Project	<b>IEEE 802.16 Broadband Wireless Access Working Group</b> < <a href="http://ieee802.org/16">http://ieee802.org/16</a> >	
Title	Corrections and clarifications to OFDMA LDPC Coding	
Date Submitted	<b>2005-06-08</b>	
Source(s)	Robert Xu, Liujun Hu ZTE Inc. 5/F, Bldg.702, Pengji Industrial Park, Liantang, Shenzhen, 518004	Voice: +86 755 26773000 6574 Fax: +86 755 26773000 6616 mailto: <a href="mailto:xu.jun2@zte.com.cn">xu.jun2@zte.com.cn</a> <a href="mailto:hu.liujun@zte.com.cn">hu.liujun@zte.com.cn</a>
Re:	Response to Sponsor Ballot on IEEE802.16e/D8 document	
Abstract	In this contribution, we suggest that some text description should be modified to make the matrix be uniform with the text description.	
Purpose	To incorporate the text changes proposed in this contribution into the 802.16e/D8 draft.	
Notice	This document has been prepared to assist IEEE 802.16. It is offered as a basis for discussion and is not binding on the contributing individual(s) or organization(s). The material in this document is subject to change in form and content after further study. The contributor(s) reserve(s) the right to add, amend or withdraw material contained herein.

# Corrections and cla

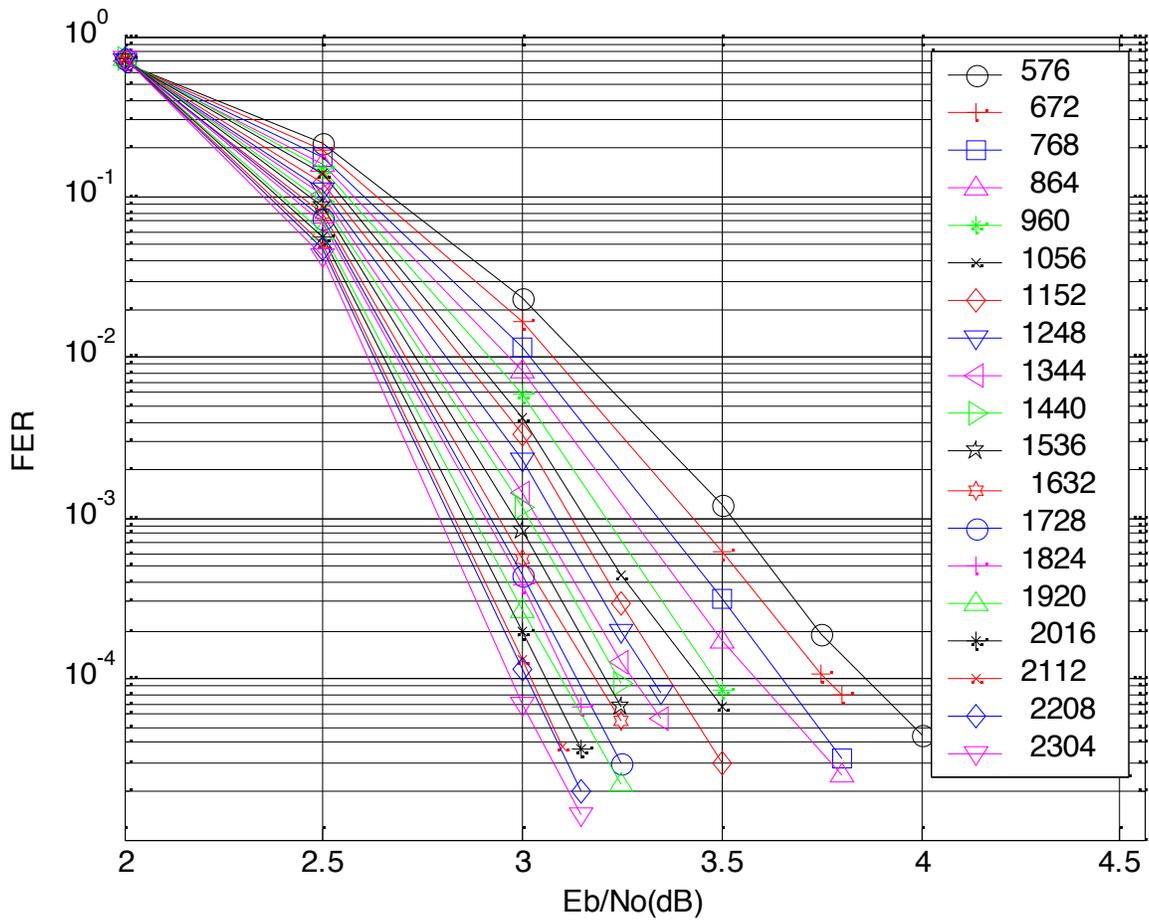
In P802.16e/D8, 24-column base matrix has been adopted, and dual-diagonal structure corresponding to parity check bits also has been used. For the base model matrix of rate 1/2, 2/3 A and B, 3/4 A codes, the first column of the part corresponding to parity bits has adopted “a-0-a” structure. However, for the base model matrix of 3/4 B codes, the first column of the part corresponding to parity bits has adopted “0-a-0” structure.

Method 1 in 16e draft can be completely used to finish the encoding process of rate 3/4 B codes. For method 2 invented by Richardson, if  $\mathbf{f} = ET^{-1}B + D = z - p(x, k_b)$ , method 2 also can be used to finish the encoding process of rate 3/4 B codes, here  $p(x, k_b)$  has been defined in the formula 129b) of P802.16e/D8. We can prove the conclusion above. So, we can conclude that rate 3/4 B codes are uniform with encoding method in 16e draft.

However, in order to get better uniform form about LDPC base model matrices, we suggest that the base model matrix of rate 3/4 codes should be changed from “0-a-0” encoding structure to “a-0-a” encoding structure. Through careful selection and simulation, we can ensure that the text change will not affect the performance of original rate 3/4 B codes.
